**STATE OF ALASKA DEPARTMENT OF TRANSPORTATION & PUBLIC
FACILITIES (DOT & PF)
DALTON HIGHWAY MP 0-9 RECONSTRUCTION
VALUE ENGINEERING STUDY
FINAL REPORT
JULY 25, 2017**

This Value Engineering (VE) report is presented to the Alaska Department of Transportation and Public Facilities (DOT & PF) to assist in decision making at the 40% design level. The goals for this VE study were to identify component and planning alternatives that may offer first cost or life cycle cost benefits and/or improve project quality. During the kick-off meeting, the design team defined the following criteria as most important to the project:

PROPOSAL	G3
COMPONENT: Geotechnical – Permafrost Provisions – Deep Excavation/ Oversized Embankments	AUTHOR	MEK

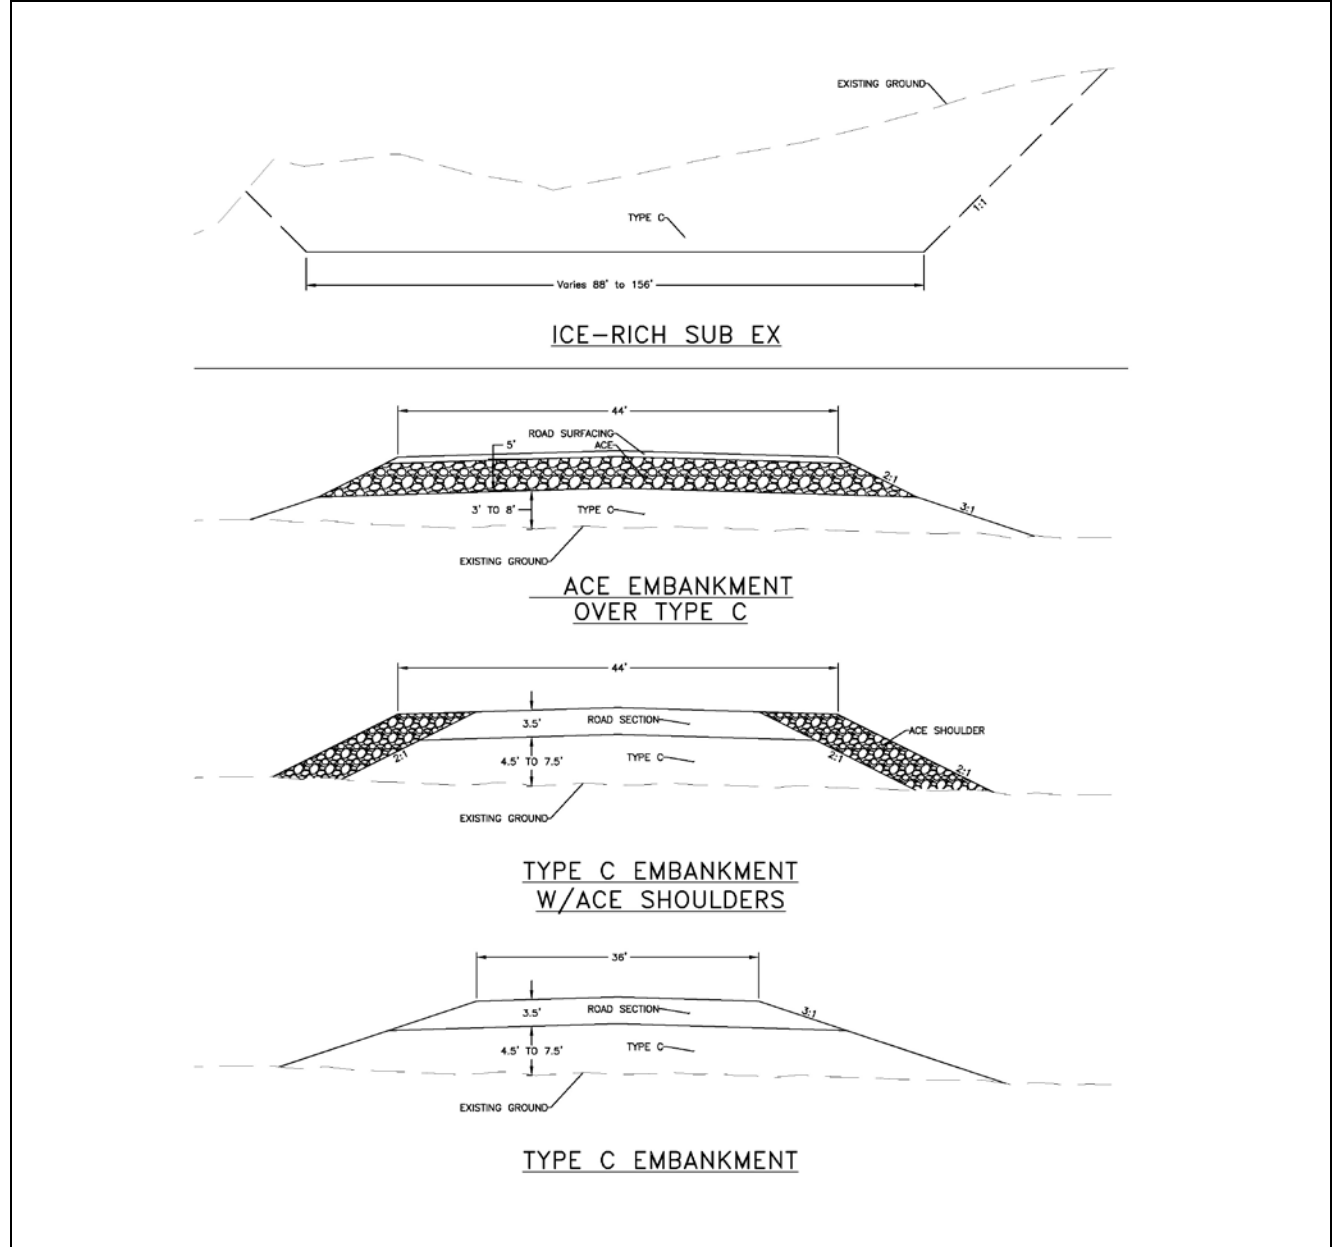
PROPOSAL	G3
COMPONENT: Geotechnical – Permafrost Provisions – Deep Excavation/ Oversized Embankments	AUTHOR	MEK
<p>The combination of a Type C embankment with the subex of ice rich soils / backfill with Type C would further reduce the potential for settlement while still being considerably more cost effective than ACE.</p> <p>Insulation could be placed on embankments less than 10 feet in height (an estimated 25% of the alignment).</p>

G2	Geotechnical - Permafrost Provisions - Tundra Excavation	74,000	X			\$74,000	This will be added along with the requirement that clearing is to occur during the winter (or frozen conditions).
G3	Geotechnical - Permafrost Provisions - Deep Excavation / Oversized Embankments	4,149,000			X		This proposal will/may be utilized at very limited/select locations and only during winter and only as scheduling would practically accommodate. Overall, NR is uncomfortable subexcavating to remove frozen material as the risk is uncertain yet potentially high, not only due to the uncertainty of the limits of excavation or the conditions encountered but also due to the negative scheduling impacts these ambiguous "dig outs" could have, primarily as they would all take place along the new road and likely sole haul route. There is also some moderate risk in efforts necessary to maintain CGP compliance. There are isolated locations, however, where the limits of are either better known or will have a more manageable amount of potential risk.

Increase ACE Height

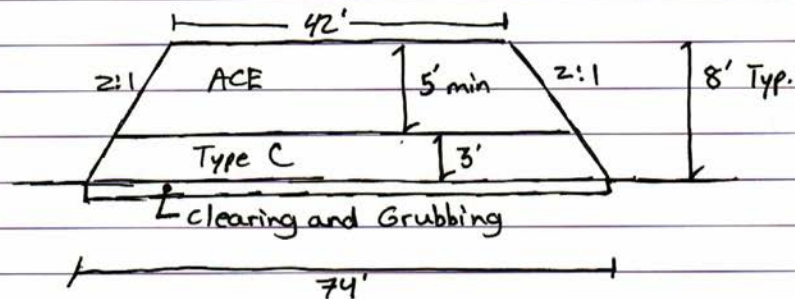
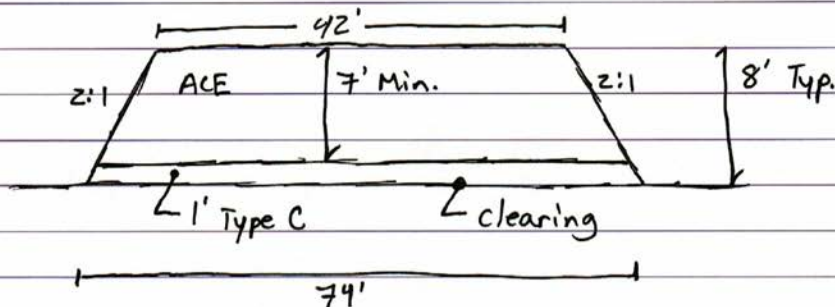
PROPOSAL	G4
COMPONENT: Geotechnical – Permafrost Provisions – ACE Embankment Height	AUTHOR	DJ
CURRENT CONCEPT: Winter construction: clear and grub, Type C, and 5’ Min. ACE. Spring construction: clear, Type C, and 7’ Min. ACE. (Assume design will use 5’ Min. ACE fill).		
VE CONCEPT: Winter or spring construction: clear, Type C, 6’ Min. ACE.

5' Min. ACE Fill (Winter)

7' Min. ACE Fill (Spring)

Known: Total length of Full ACE = 14,550 LF
ACE = \$50/Ton
Borrow = \$5/cy
Clearing and grubbing = \$8,000/Acre
Clearing = \$5,000/Acre

G4	Geotechnical - Permafrost Provisions - ACE Embankment Height	(1,955,000)		X			This proposal was rejected as the basis for ACE height was determined from thermal modeling based on the expected conditions. Simply averaging the heights could result in excessive heights in some areas and insufficient heights in others. The final thicknesses may change, however, due to other project design changes resulting from other accepted proposals in this VES (such as not-grubbing - G2).
C1	Construction - Schedule	2,496,000			X		This proposal restricted the field season to begin in May, however a substantial amount of work (pit development, clearing, access development, etc.) could be completed in winter conditions while still allowing the advantages of this proposal; this proposal was modified to restrict the physical work to one summer season, beginning in the fall after advertisement and a contract completion of the spring following the summer field season (approximately 18 months in total).
